**Preliminary Plan, 120120270, Esworthy Estates**

Preliminary Plan No. 120120270: Esworthy Estates  
Two lots requested for two, one-family detached dwelling units and one outlot; located at 12630 Travilah Road on the northern side of Travilah Road; RE-2 zone; 9.49-acres, 2002 Potomac Subregion Master Plan.

**Staff Recommendation:** Approval with conditions and adoption of the Resolution.

**Figure 4 – Tree Variance**

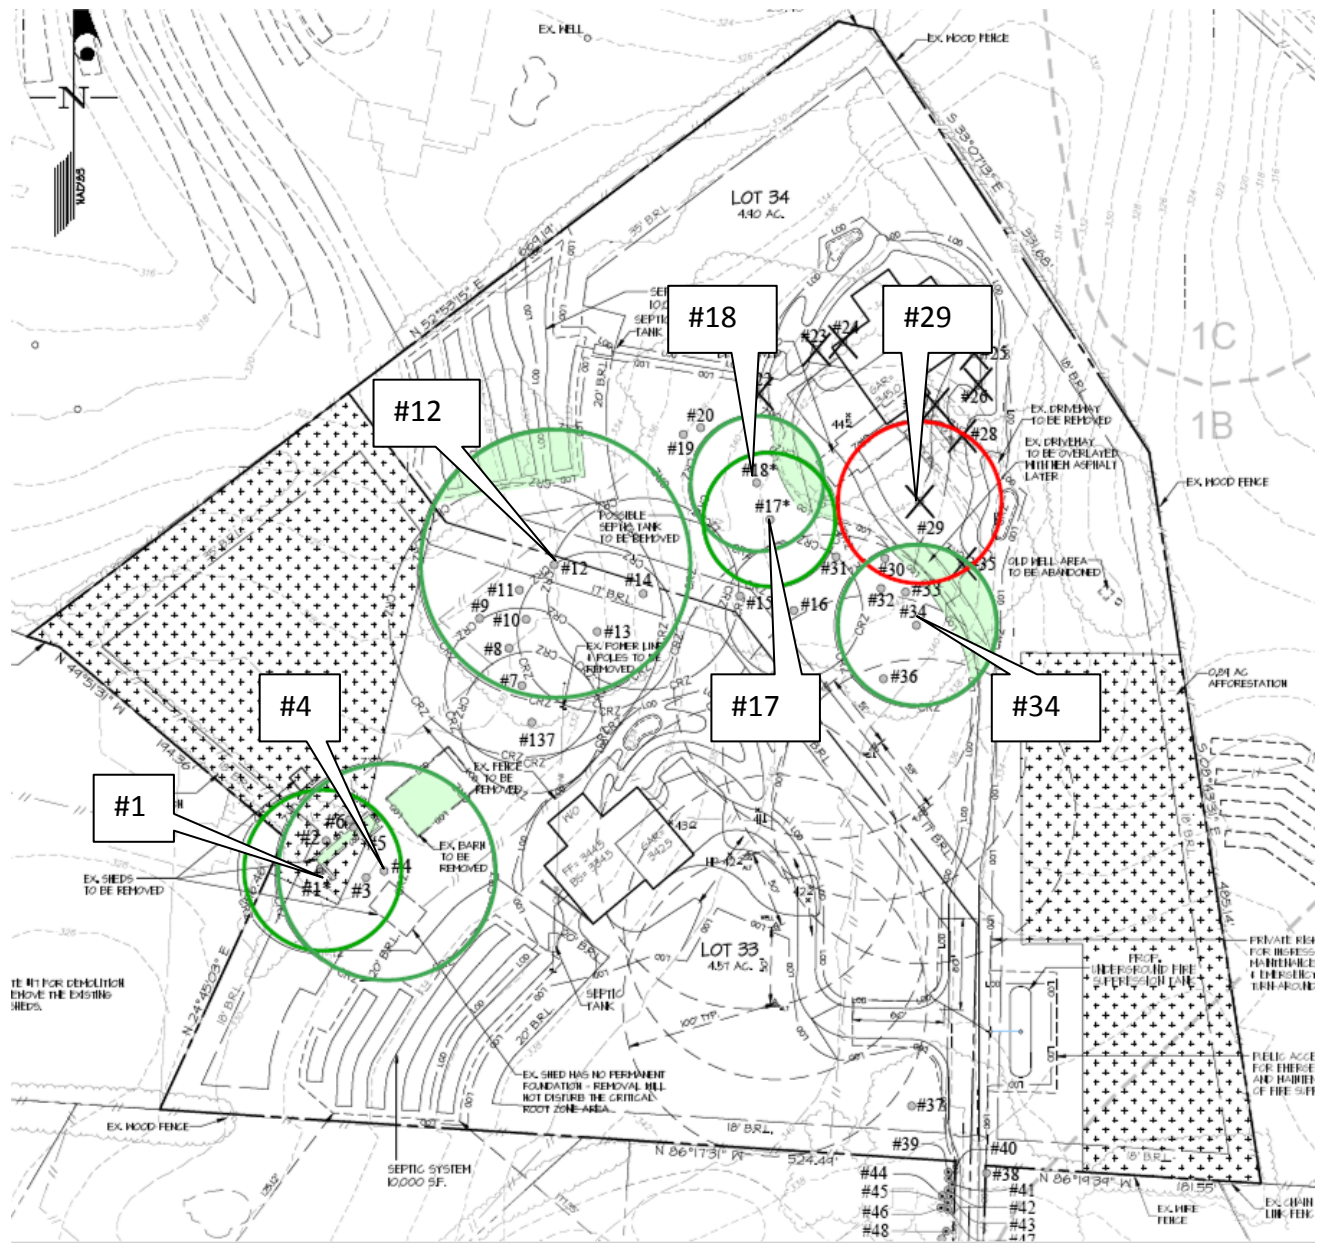
A variance is required since this project will require that one tree 30 inches or greater in diameter at breast height (“DBH”) (“Protected Trees”) be removed (Tree #29 shown in red) and that there will be impact to six other Protected Trees (Trees # 1, 4, 12, 17, 18, and 34 shown in green) depicted in Figure 4.

Mitigation should be at a rate that approximates the form and function of the Protected Tree removed to provide some mitigation for water quality protection as the mitigation trees grow and mature. Staff recommends that replacement occur at a ratio of approximately one inch DBH for every four inches DBH removed, using trees that are three-inches in caliper. The one Protected Tree that is being removed is a 36-inch slippery elm in poor condition. Staff recommends that this tree loss be mitigated by planting three, three-inch caliper shade trees to be shown on the Final Forest Conservation Plan.

Variance Recommendation - Staff recommends that the variance be granted.

**FIRE MARSHAL COMMENTS**

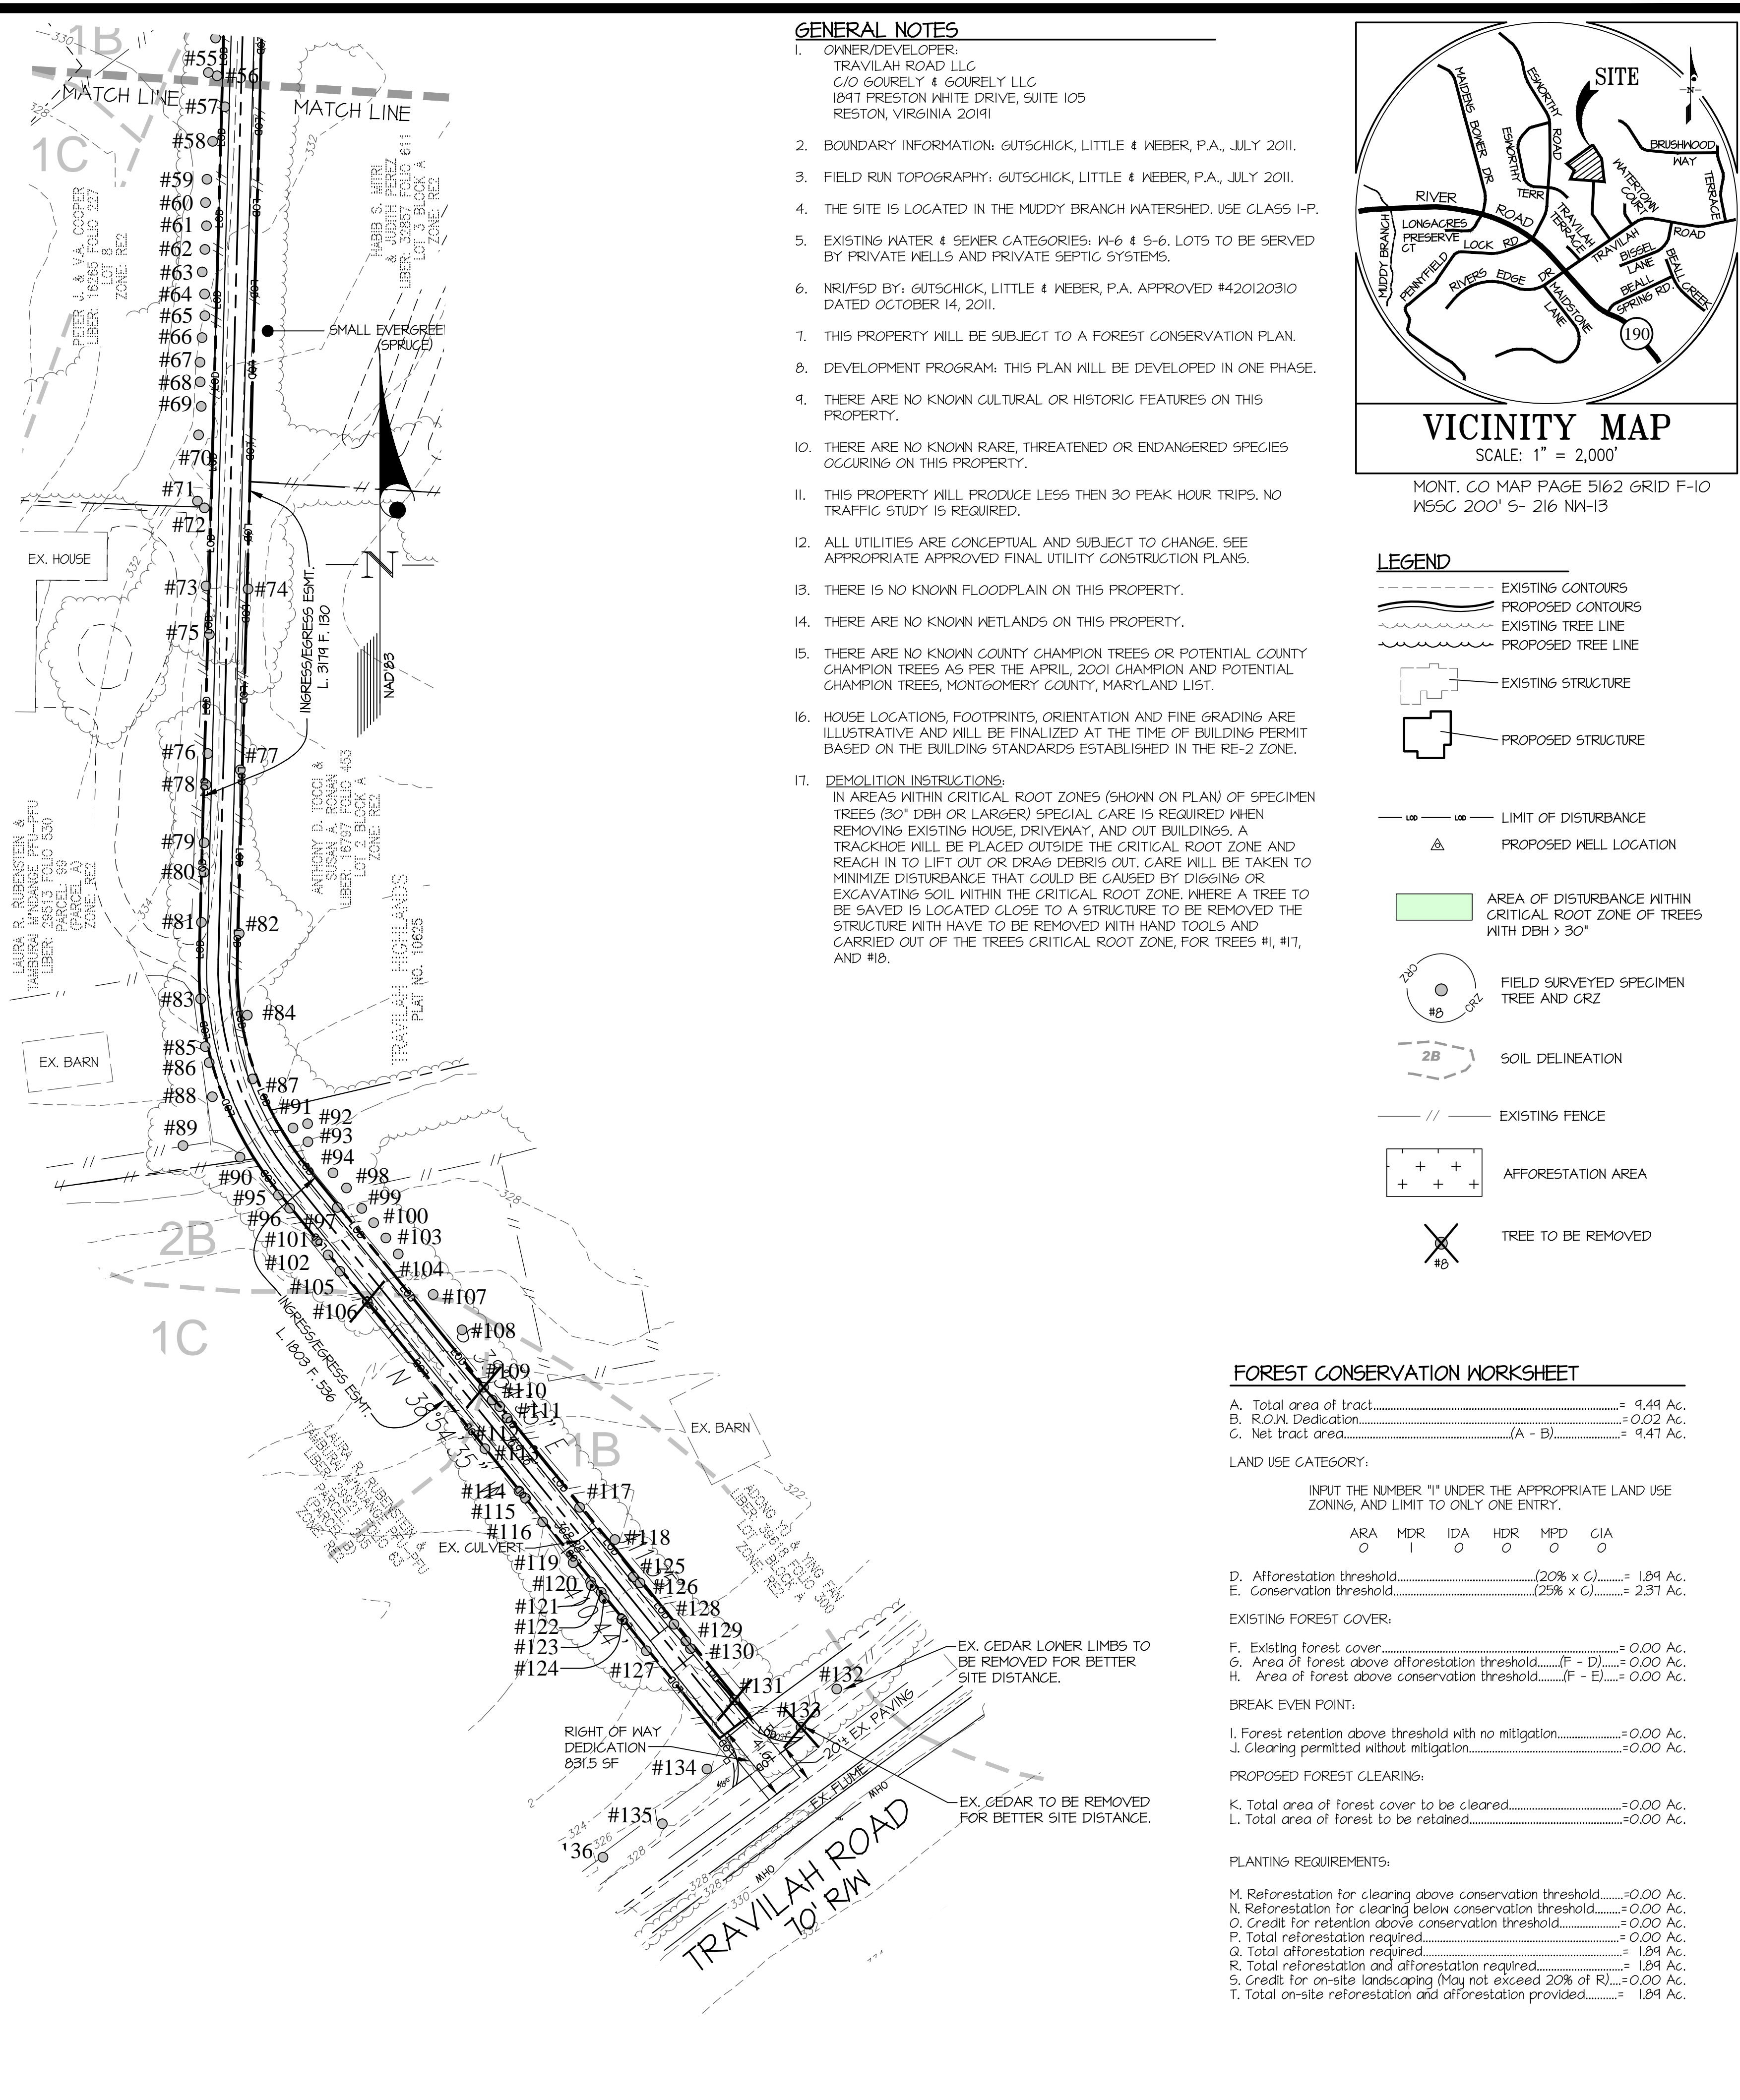
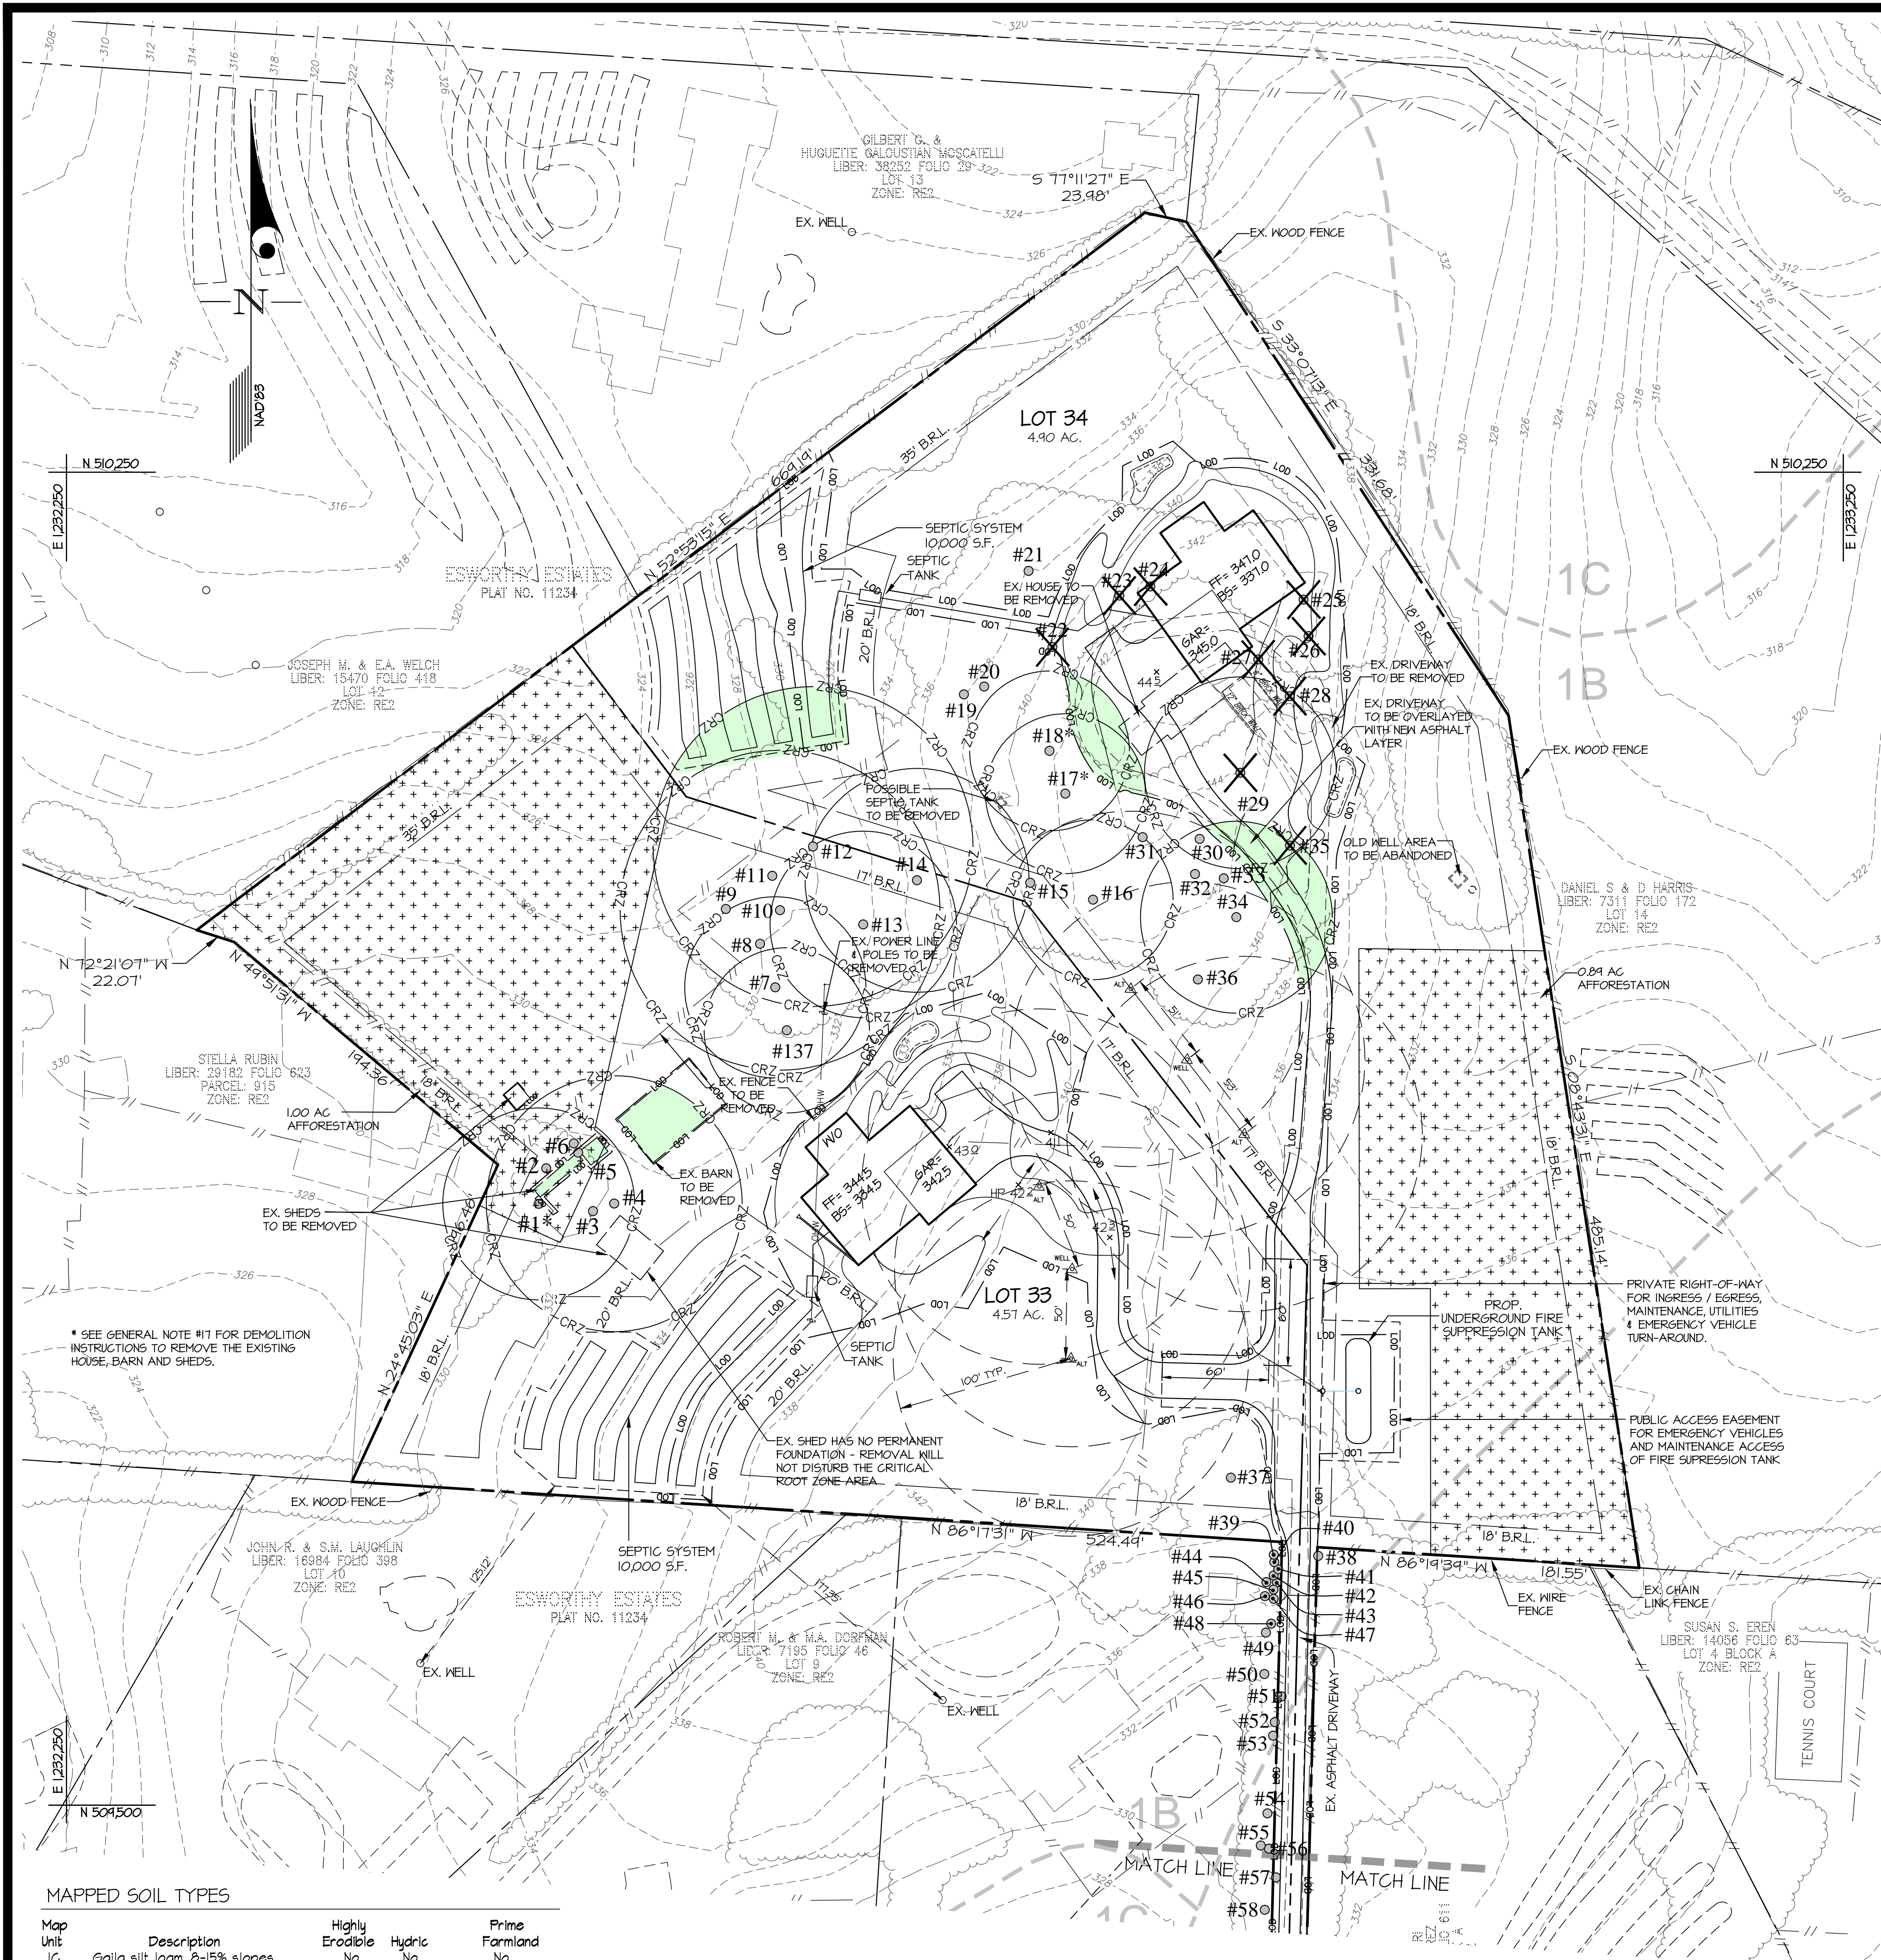
**\*\*\* Performance based review allowed 30,000 gallon water supply tank installation in lieu of prescriptive driveway access \*\*\***

**PLAN APPROVED**
